### PLAN COMMISSION MEETING AGENDA Thursday, May 9, 2024 at 6:00 P.M.

# CITY OF FRANKLIN REPORT TO THE PLAN COMMISSION

## Meeting of May 9, 2024 SPECIAL USE & SITE PLAN

RESOLUTION NO. 2024-\_\_
A RESOLUTION APPROVING A SITE PLAN FOR LAKE GROVE PLACE,
A MULTI-FAMILY RESIDENTIAL DEVELOPMENT
(3709 W COLLEGE AVENUE)
(SAFARI HOMES FRANKLIN LLC, APPLICANT)

NATURAL
RESOURCE
PROTECTION
PLAN

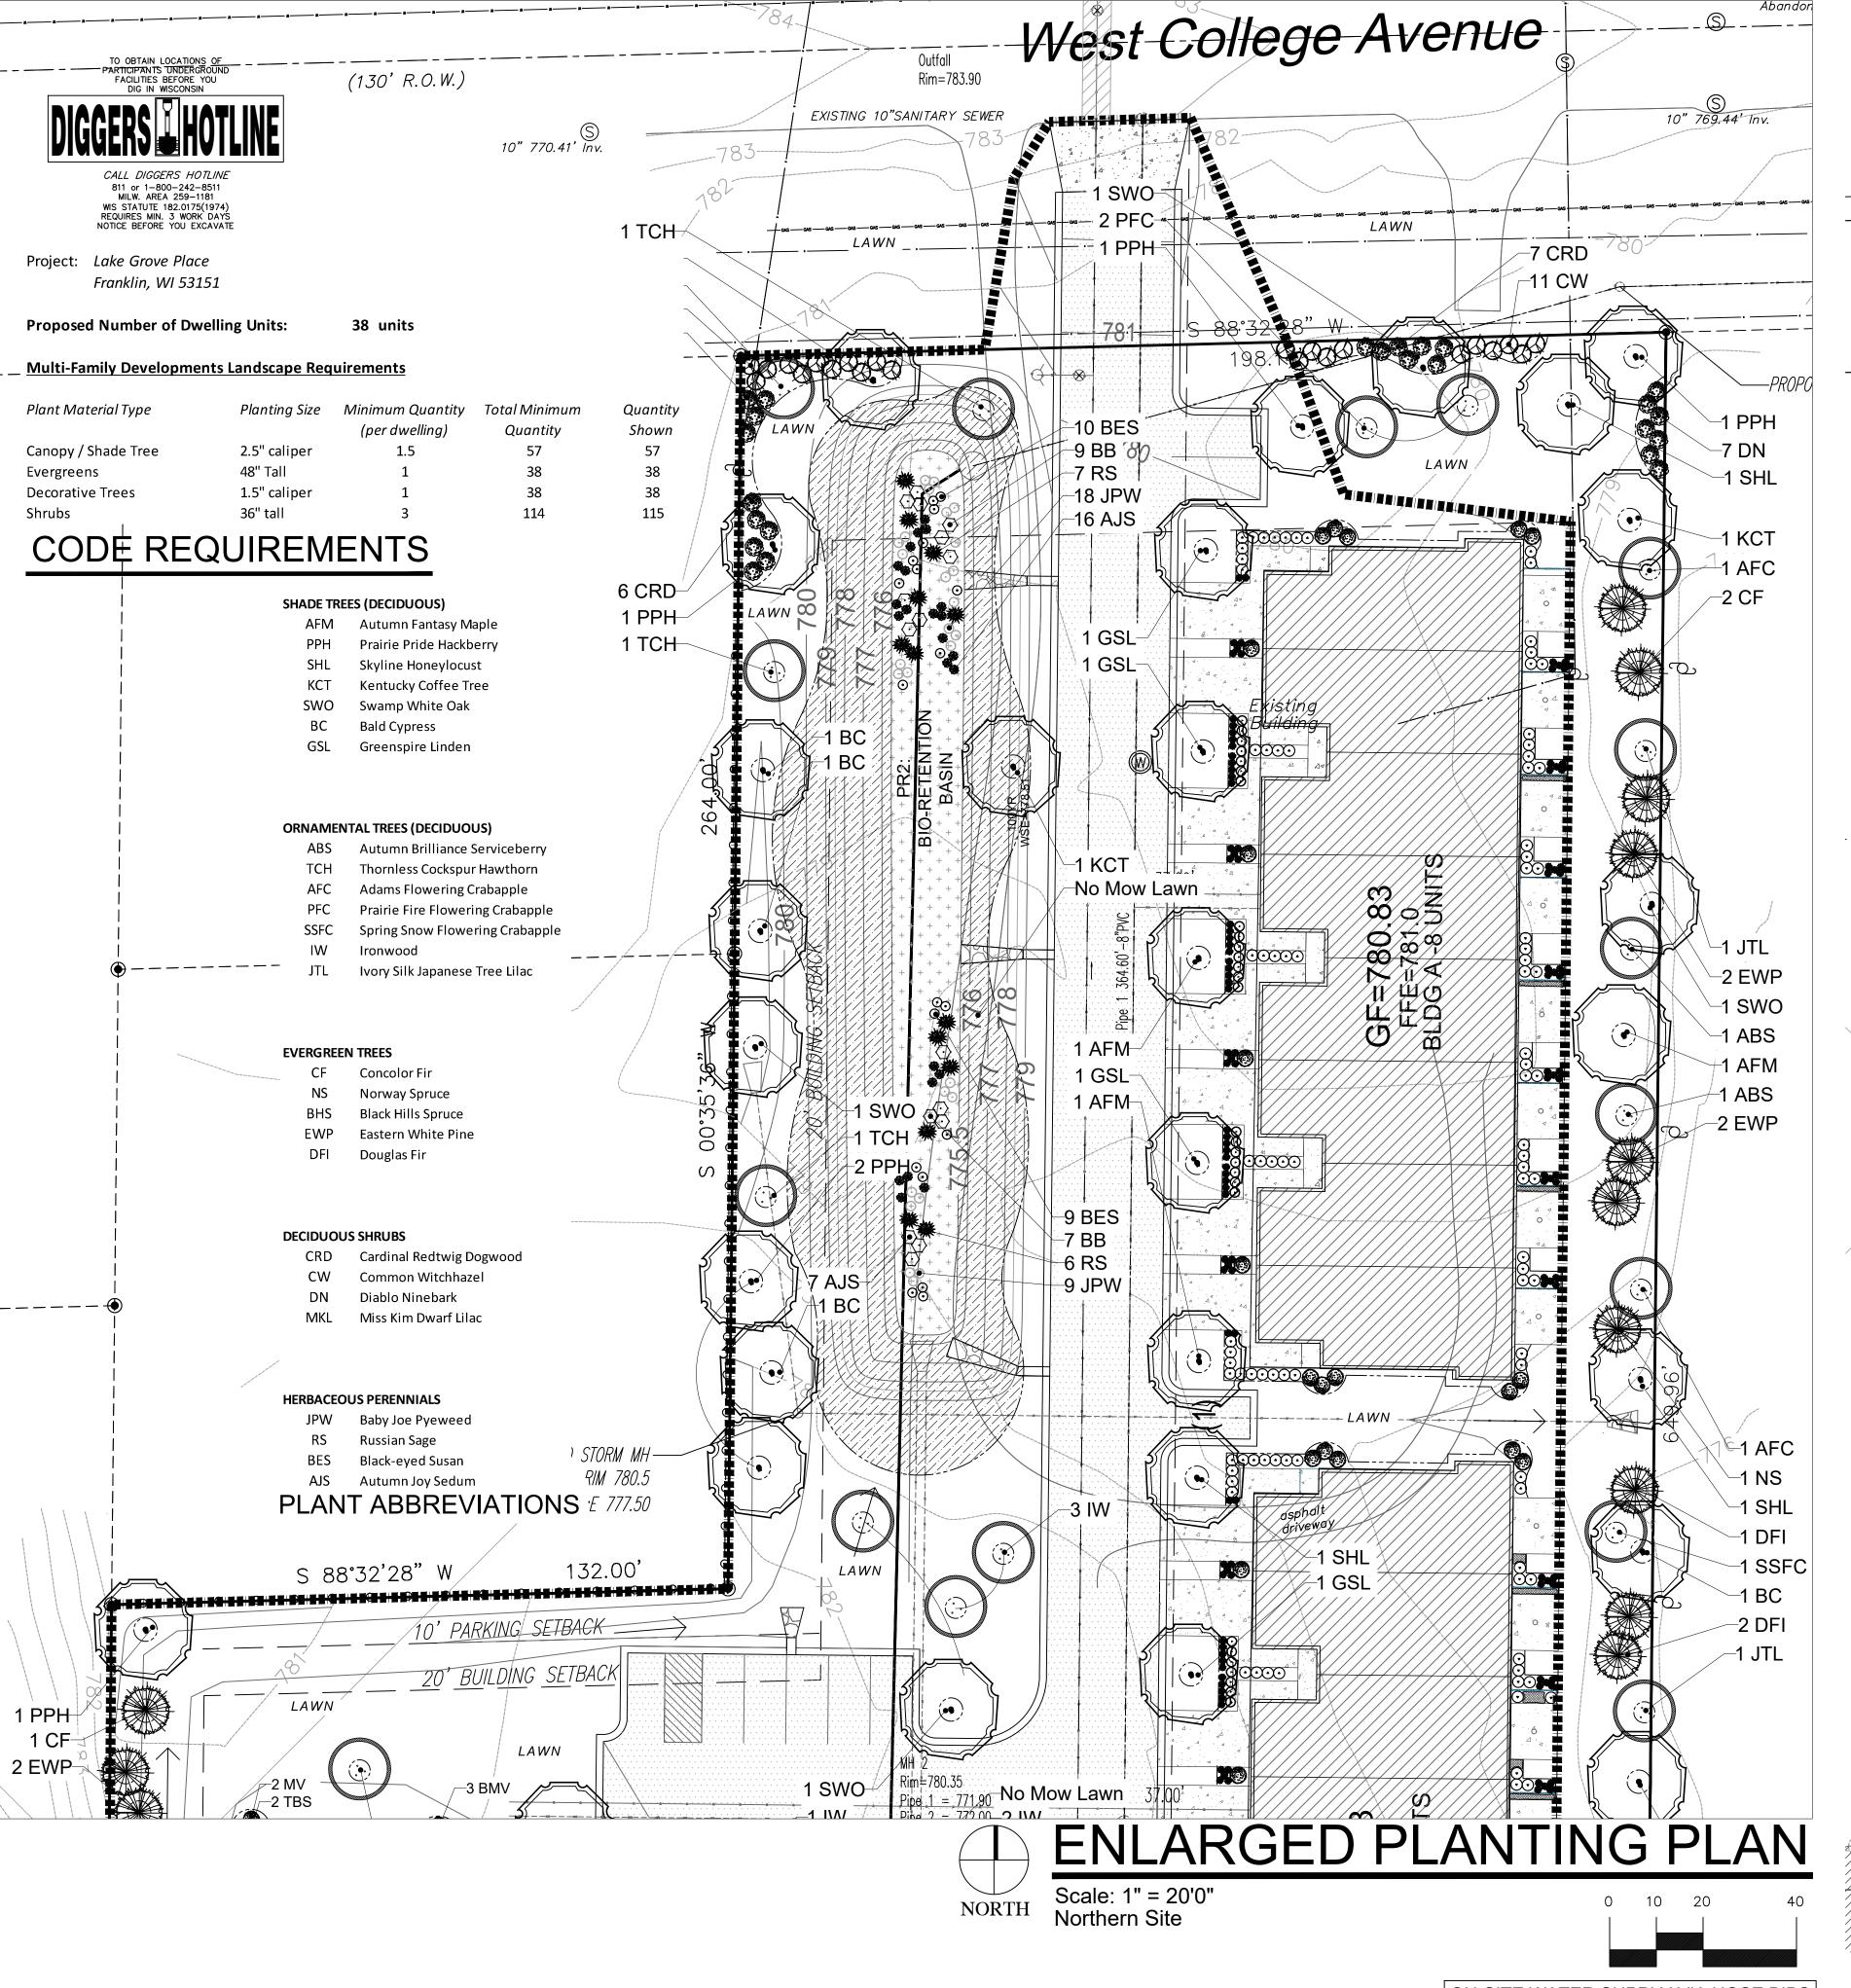
Futher, Table 15-3.0503 "Worksheet For the Calculation of Resource Protection Land" has been added to the plan sheet L1.0 (Natural Resource Protection Plan) for this project, with a revision date of January Should you have any quesions on any of these materials, I would be happy to speak with you personally.

# CERTIFIED SURVEY MAPNO.

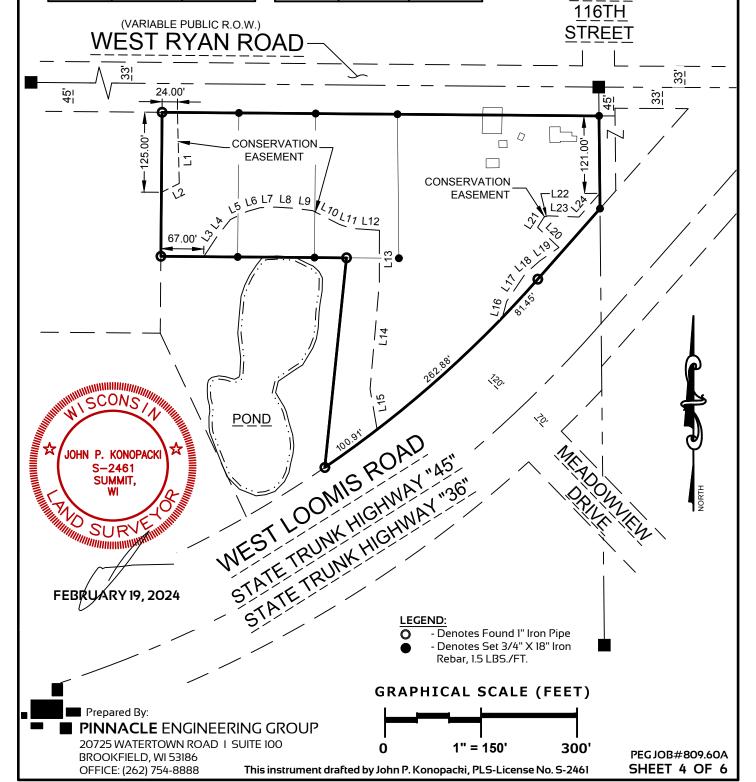
5. Natural resources required to be protected. Natural resources that are required to be protected per UDO Table 15-4.0100 must be depicted in the CSM (UDO §15-9.0309E). The CSM only depicts the pond and shore buffer (sheet 3 of 5) but doesn't depict the mature woodlands and steep slopes (10-19%) areas required to be protected. Pursuant to the referenced table, the protection standard in residential zoning for mature woodlands is 70% and for steep slopes (10-19%) is 60%.

#### Figure 7. Field Delineated Wetlands

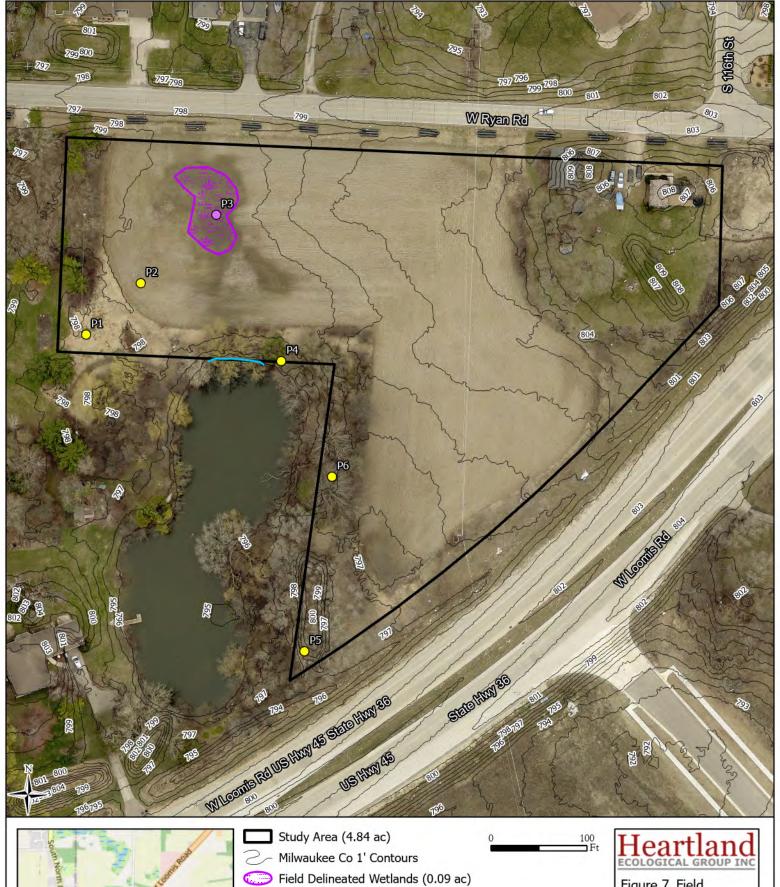
3. **Shore buffer.** The NRPP table states that the shore buffer is "based off wetland delineation". Please note that shore buffers must be delineated from the ordinary high water mark (OHWM), not a delineated wetland, please clarify. For reference, see wetland delineation report, figure 7.

10885 SOUTH 27TH STREET - NATURAL RESOURCES PROTECTION PLAN

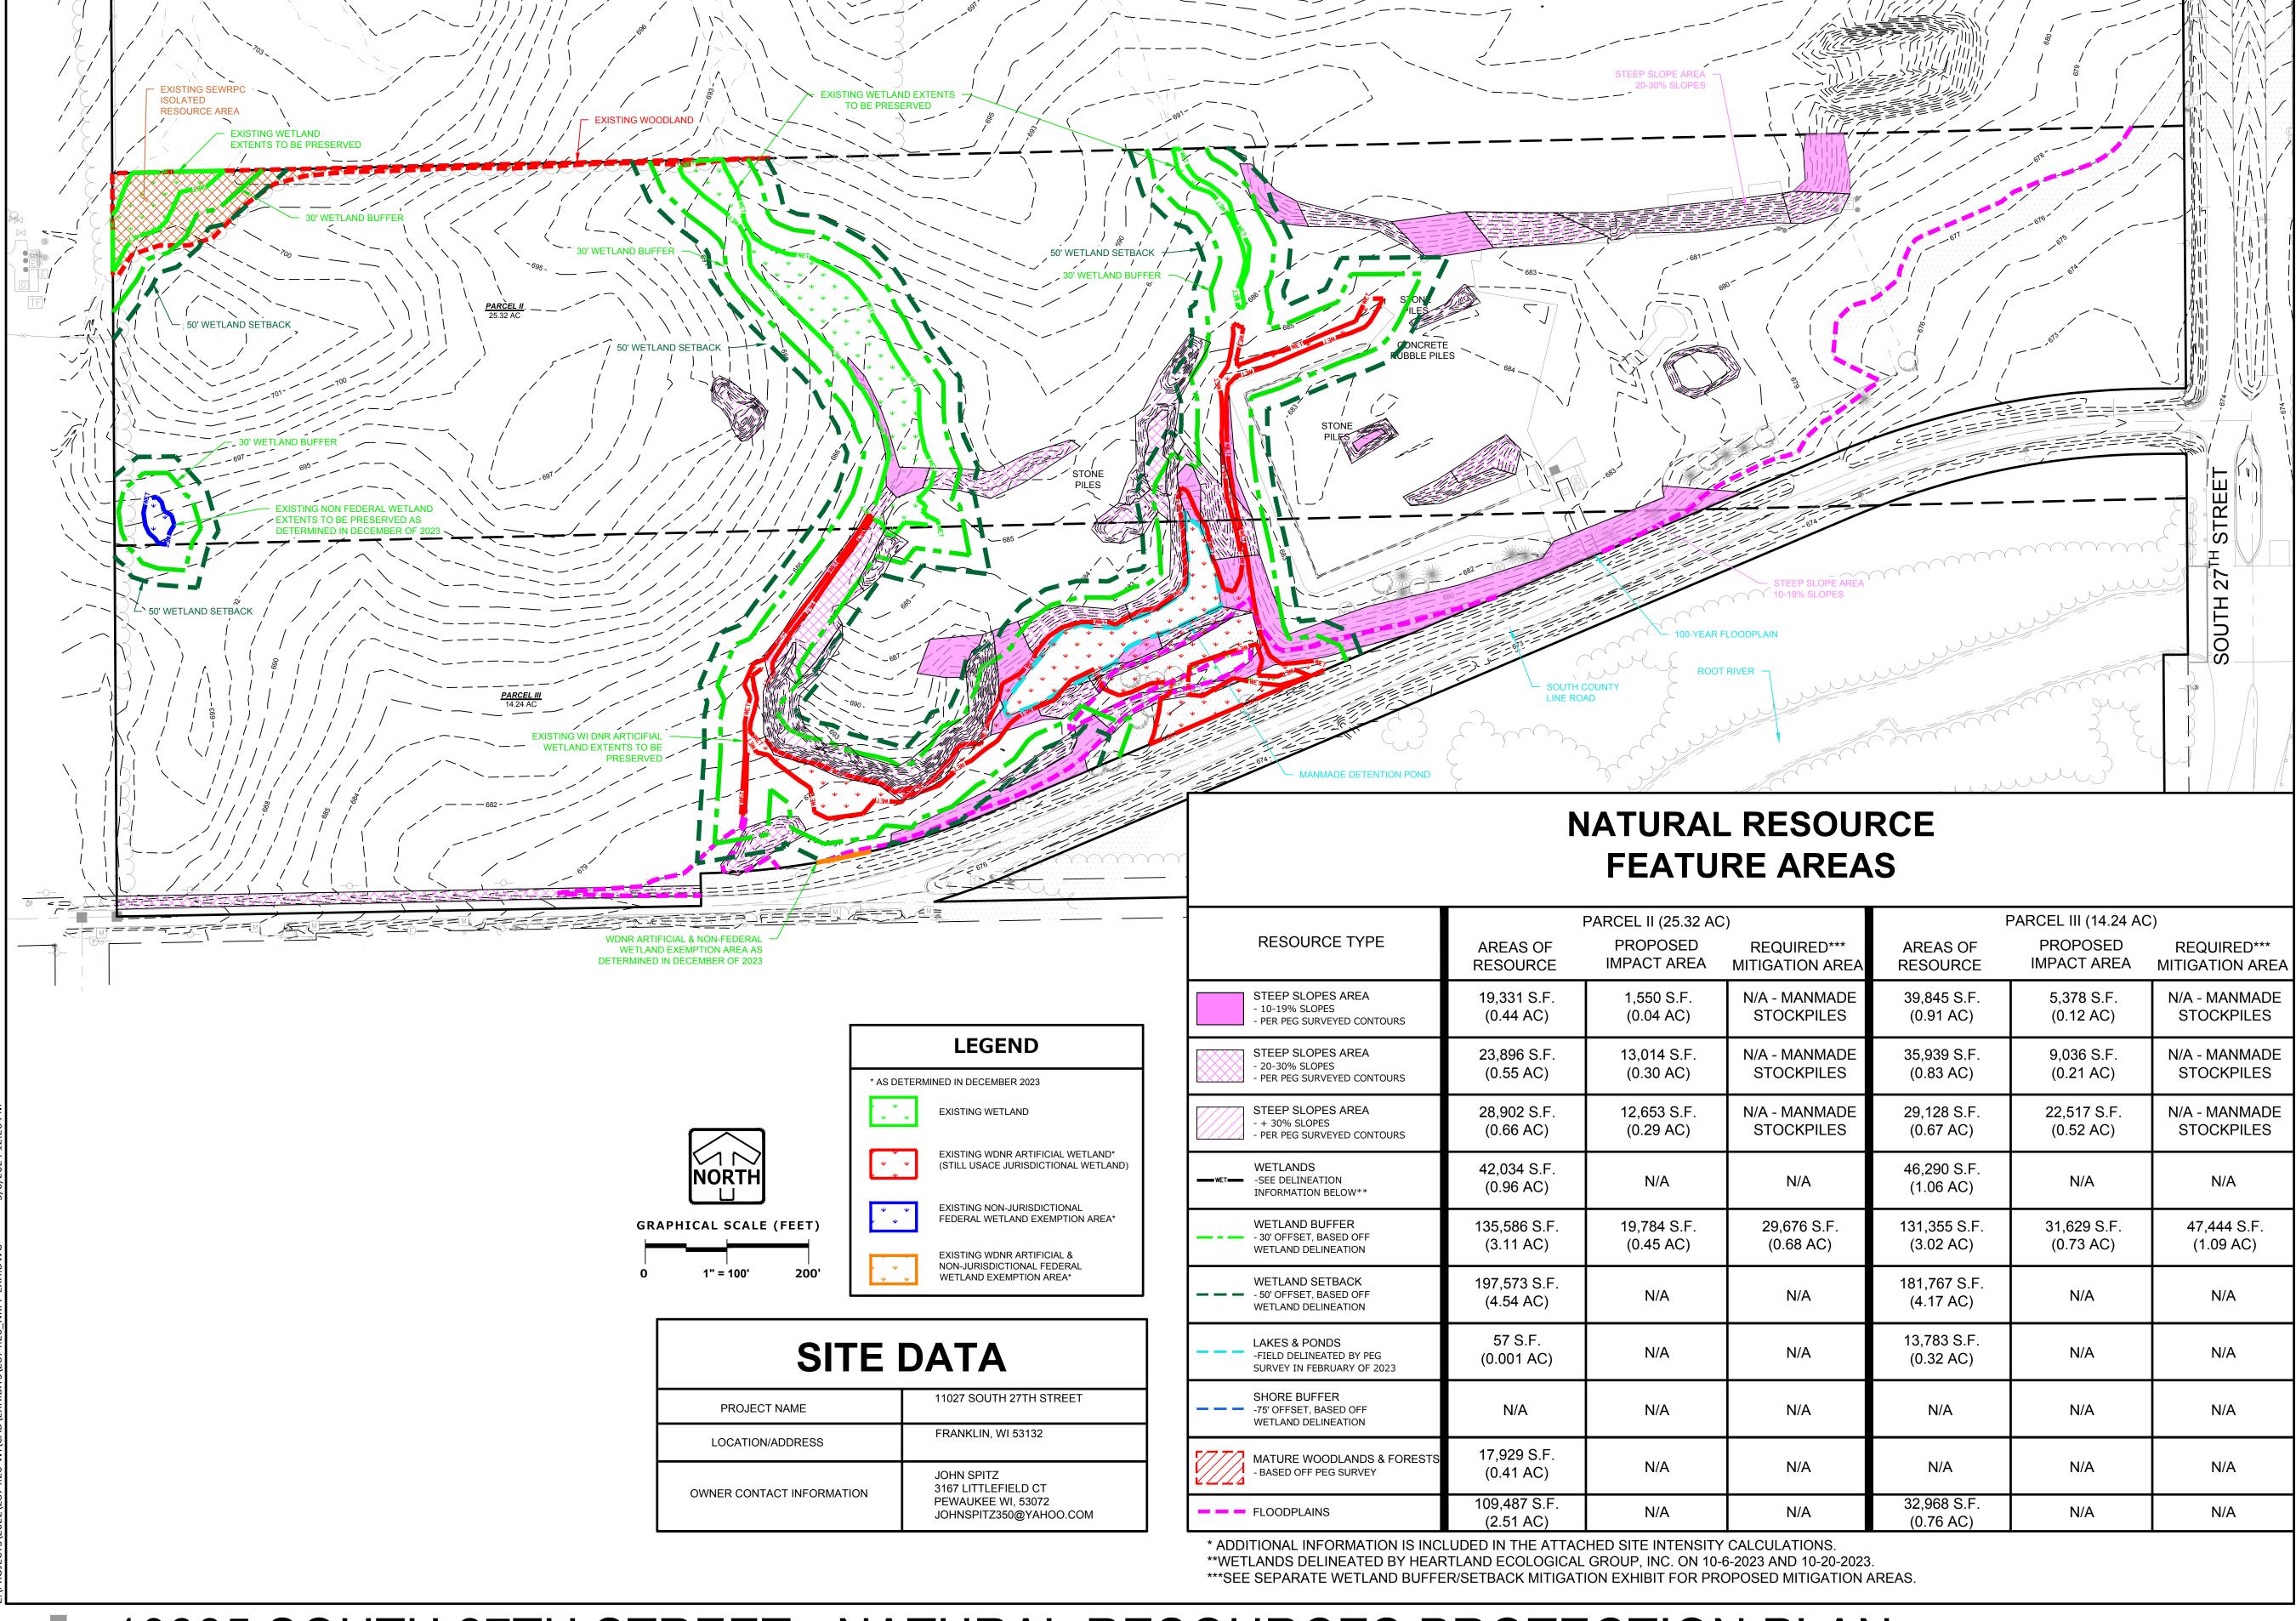
In addition to natural resource protection violations that must be remediated, the application is proposing the following:

- Grading in wetland Buffer, which requires a Natural Resource Special Exception.
- Possible work in FC Floodplain Conservancy areas, which is not permitted.
- Possible work in areas that are part of the federally regulated floodplain, which requires an NRSE and Land Use Permit, or an amendment to the Federal Insurance Rate Maps.
